37/3 7114 Poplar Ave. SA 4-88

Historic Preservation Commission

7114 Poplar Avenue (Shields)

LOCAL ADVISORY COMMITTEE REVIEW FORM

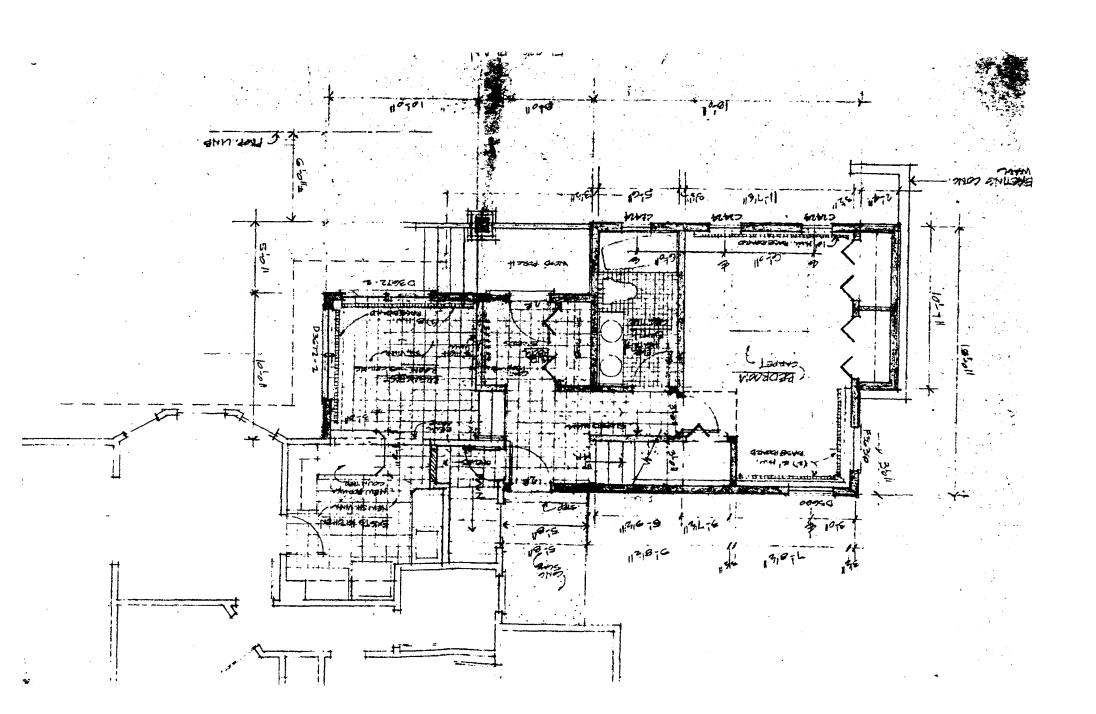
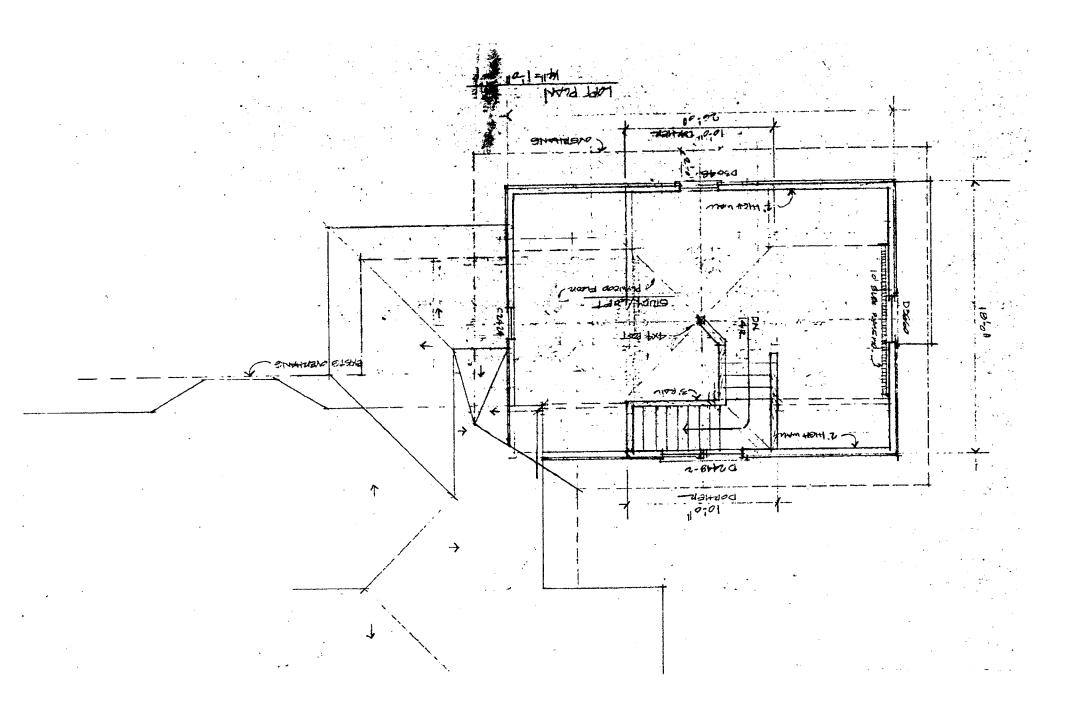
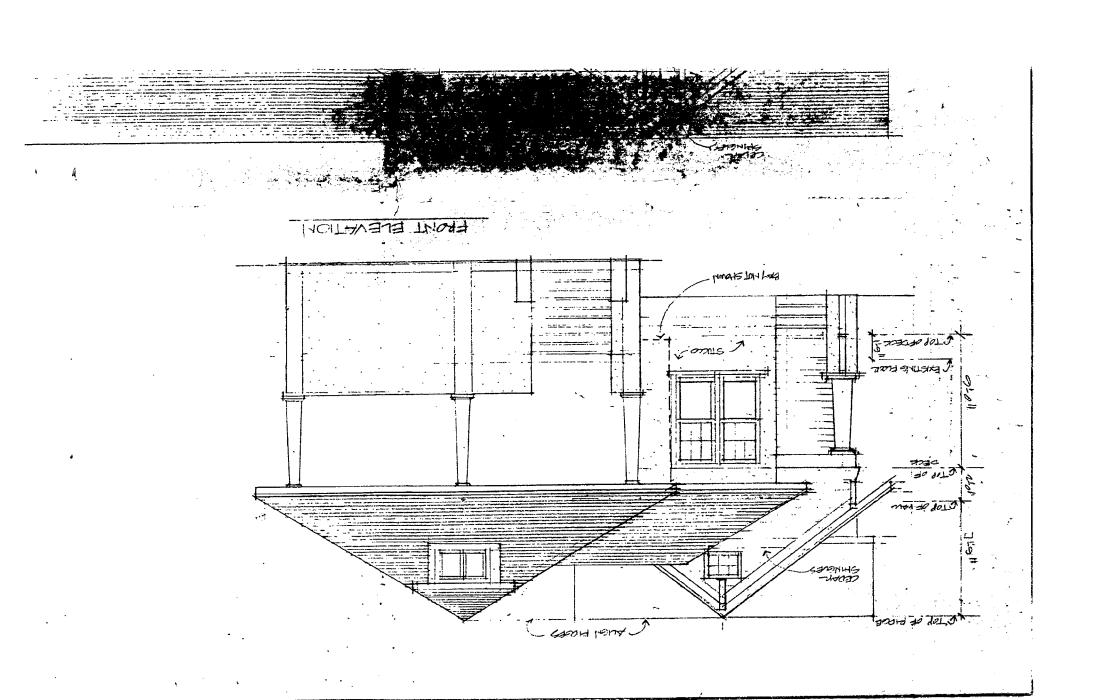
This is a follow up presentation to the architect's first original submittal at the January meeting. Although the design goes far in achieving a balance between compatability and separation (to distinguish old from new), some concern was expressed during the previous meeting about the steeper slope the roof to the addition. A shallower slope, members suggested, would be more sympathetic with the original structure and less likely to give the illusion a taller, more vertical structure behind the historic house. Doug Dunn and Caroline Alderson added that the slope of the addition was inappropriate for a bungalow-period house. Mr. Dunn expressed concern that the rear portion of the addition might be mistaken for another historic cottage on the lot. Other members judged that the addition was more an allusion to than a replication of a period bungalow, that the importance of compatability overrides concerns about separation of old and new in small residential districts, and that homeowners should not be compelled to design additions in a contemporary style any more than in a particular historical style.

The architect agreed to try modifying the design to match the slope of the new roof to that of the original house. However, upon presentation of the revised designs, members agreed that the bulky appearance creating by raising

the side walls (to lower the slope without lowering the ridge and losing required head clearance) made the new addition considerably more conspicuous than the unequal roof pitches did. The committee recommends approval of the first design (enclosed) as submitted.

In response to committee suggestions,
This is the architect's second submittal. Mr. Treseder agreed to designathen prepare
an alternate design lowering the pitch of the rear structure to match that of the original
house. However, on second review, members aggeed raising the height of the side walls
to create a shallower roof pitch (ridge could not be lowered within code) limits) made
the addition appear undesireably bulkier. Therefore, the first design (attached) is

recommended as the best alternative pare on which application received: 1/11: Revised 2/9: complete 3/1/88
